City of El Paso – City Plan Commission Staff Report

Case No: SUSU14-00071 Clardy Fox Subdivision Unit III Replat Two
Application Type: Resubdivision Combination
CPC Hearing Date: August 28, 2014
Staff Planner: Alfredo Austin, 915-212-1604, austinaj@elpasotexas.gov
Location: South of Alameda and West of Buena Vista
Acreage: 0.364 acres
Rep District: 3
Existing Use: Residential development
Existing Zoning: R-4 (Residential)
Proposed Zoning: R-4 (Residential)
Nearest School: Lyndon B. Johnson Head start (.01 miles)
Nearest Park: Modesto Gomez Park (.48 miles)
Park Fees: \$2,740.00
Impact Fee Area: This property is not located in an Impact Fee Service Area.
Property Owner: Justo Gonzalez
Applicant: Justo Gonzalez
Representative: Dorado Engineering

ATTACHMENT 4

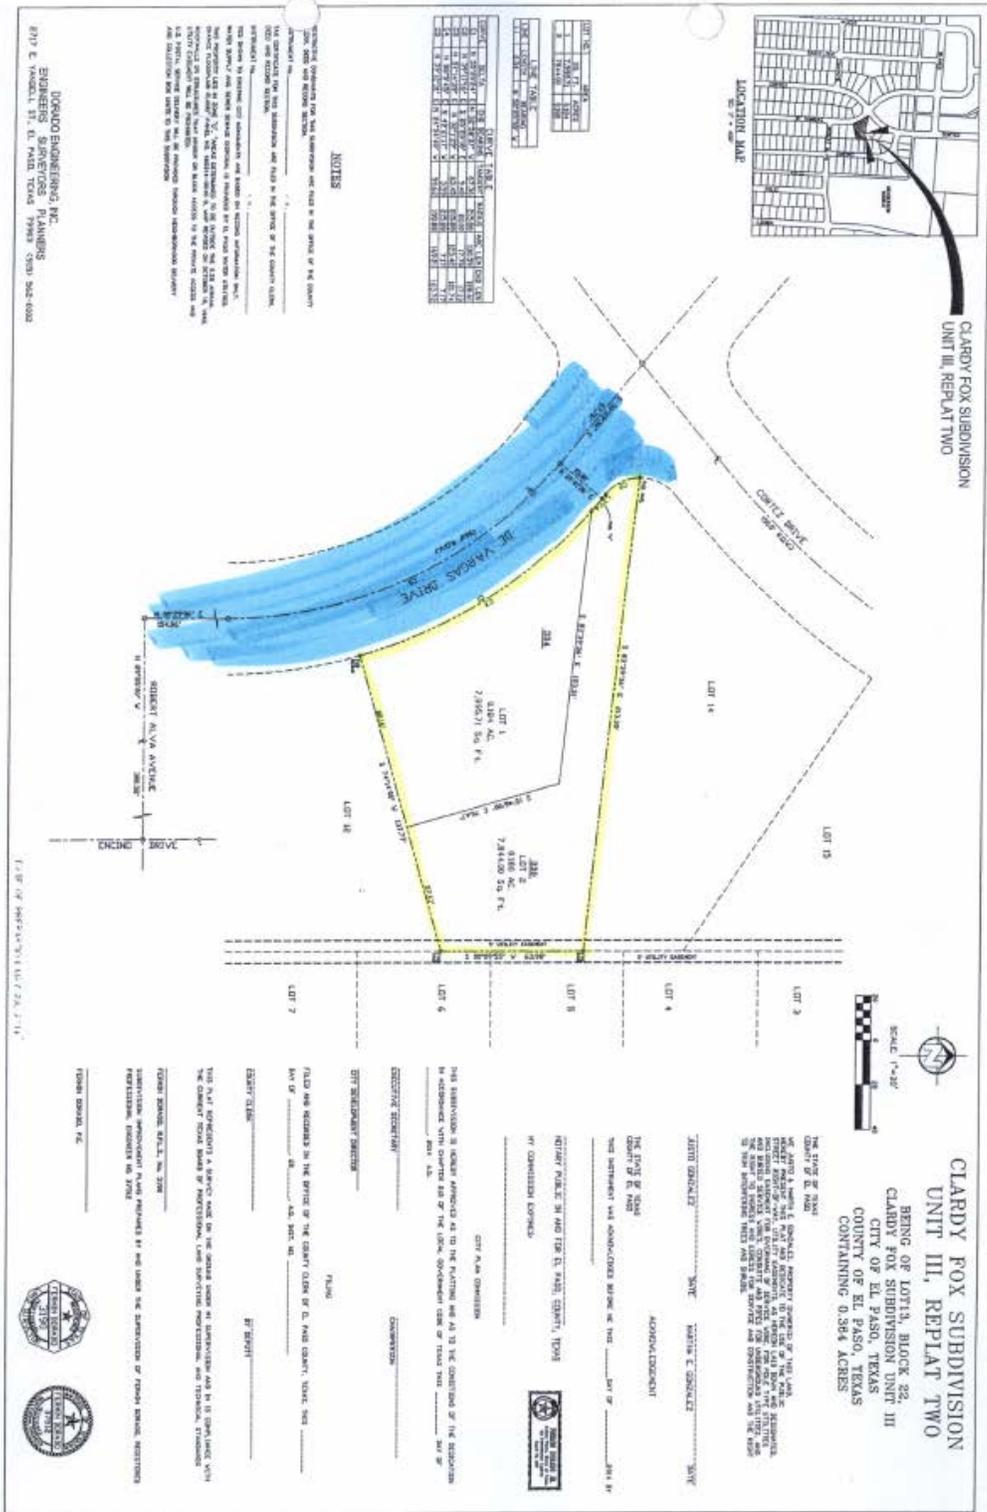
In accordance with Section 19.48, the applicant is requesting an exception to waive ROW improvements along De Vargas Drive. De Vargas Drive is a local residential street on the MTP and the standard ROW is 50' with 30' of pavement, 5' sidewalks and 5' parkways. The current ROW provides 5' sidewalks and 4' parkways.

Lot 2 features a 123.31' panhandle. As per Section 19.34.040.C, panhandle lots shall be discouraged in residential areas except when, due to unique parcel configuration it is the only way to develop the property, and it shall be considered an exception. The maximum length of the panhandle shall be one hundred feet. The minimum width of the panhandle shall be twelve feet to serve one dwelling unit. The applicant has submitted an exception request for the panhandle lot and an exception request for a panhandle exceeding 100'.

1. Driveway must be distanced a minimum of 5 ft. from the curb return (Per Section 8.3, Residential Driveways) due to proximity to the corner intersection and handicap ramp in front of school.

2. There is an existing 12-inch diameter water main extending along De Vargas Drive that is available for service, the water main is located approximately 13-ft east from the center line of the right-of-way.

6. There is an existing 8-inch diameter sanitary sewer main extending along De Vargas Drive that is available for service, the sanitary sewer main is approximately 5-ft in depth from finish grade to top of pipe. The alignment of the sewer main varies between the southwest and northwest property lines.

7. There is an existing 15-inch diameter sanitary sewer main extending along De Vargas Drive. The alignment of the sewer main varies between the southwest and northwest property lines.
